RE: Medical Center Aurora South
Aurora, Colorado

06 · 167605
CITY OF AURORA
BUILDING DIVISION
APPROVED AS NOTED Jean P
DATE 12/18/6
RSN 246592

City of Aurora Plan Review
Occ. Type: I-2
Const. Type: 1B SPK
Square Footage:
Code: IBC 2003
RSN: 24592
Permit No. 06167605

HCA TECH REFRESH

SHEET NO
A0.03

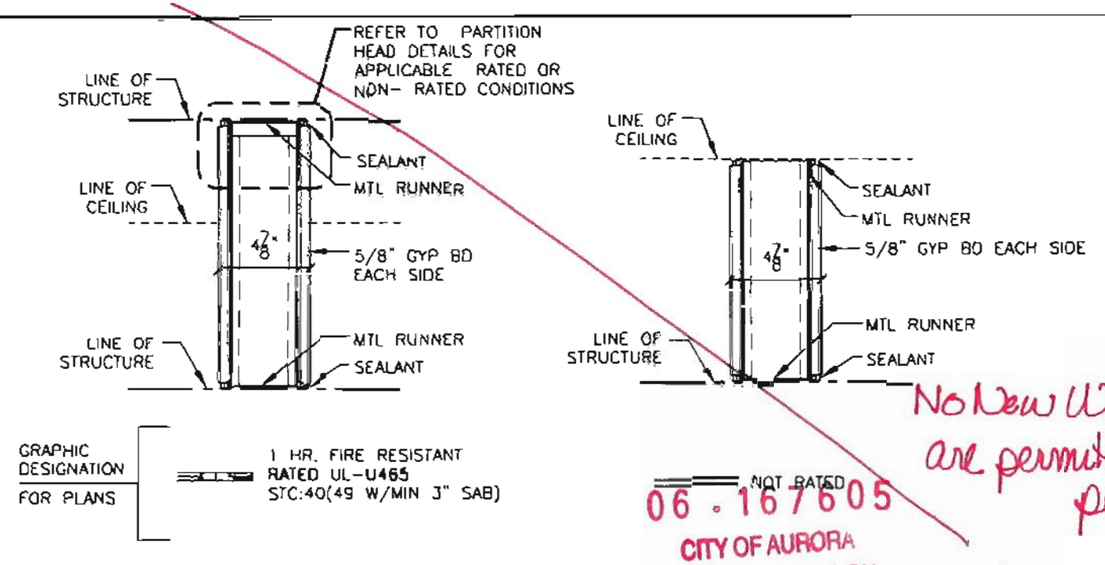
No New Walls Typ are permitted under this permit

SHEET NO
A2.01

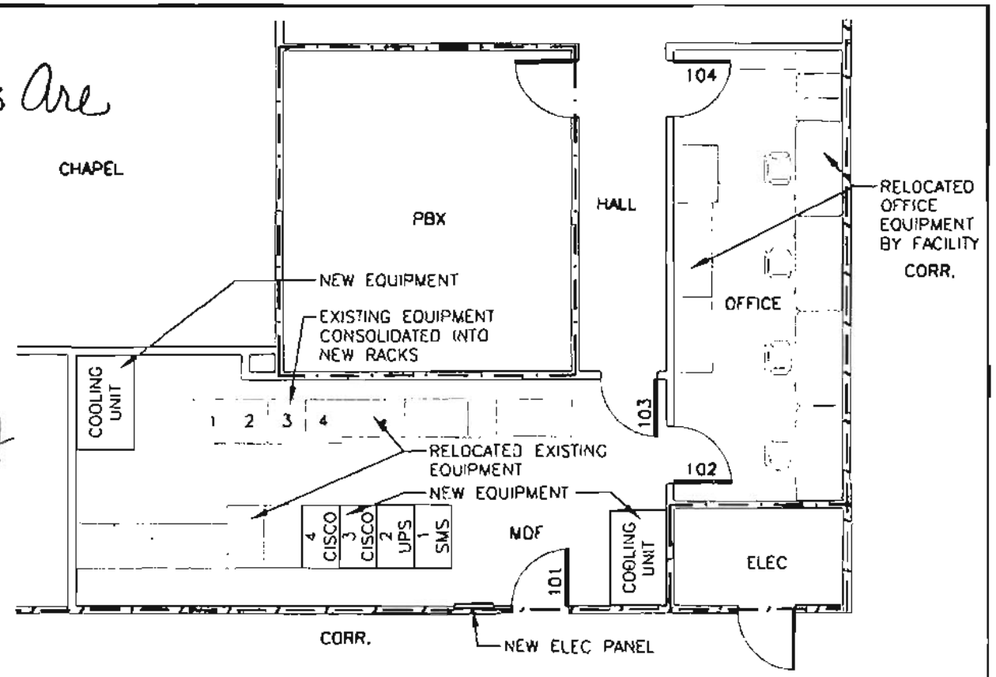
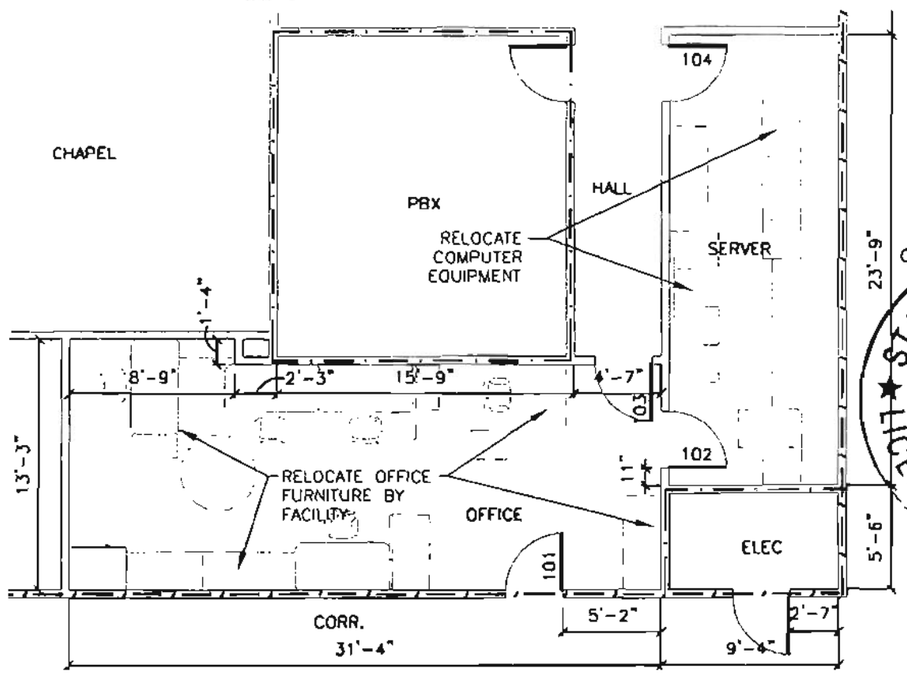
No New Walls Are
~~Beam~~

No New Walls or Wall Mods Under this permit

TRANSFORMER GROUNDING DETAIL
SCALE: NONE

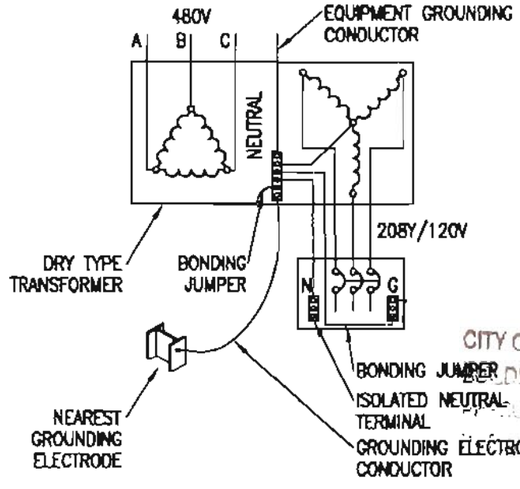
Comply with 2005 NEC
Article 408-4 and 30
Typical

SHEET NO
E1.02

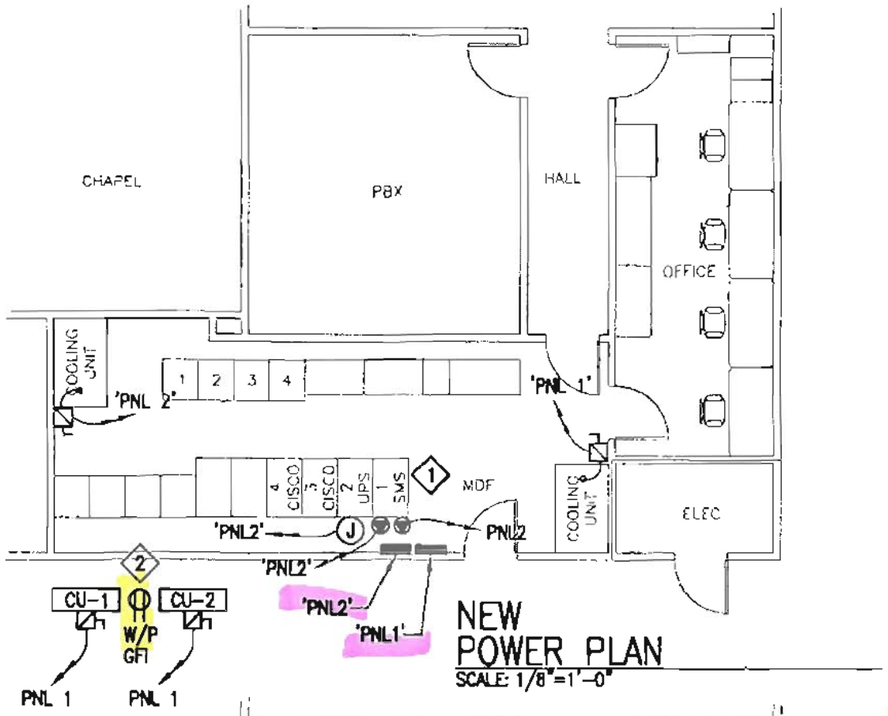
Comply with 2005 NEC Article 700-5-D and E Typical

Comply with 2005 NEC Article 517-30-D Typical

Comply with 2005 NEC Article 517-30-A Typical

SHEET NO
E2.01

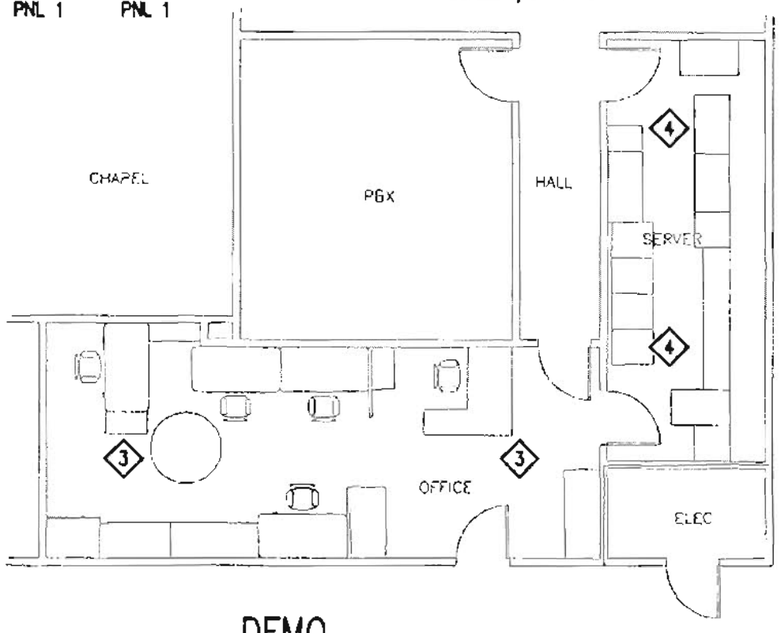
Wiring in air handling spaces must comply with 2005 NEC 300-22, Firestop penetrations per 2005 NEC 300-21, Secure and support equipment per 2005 NEC 300-11
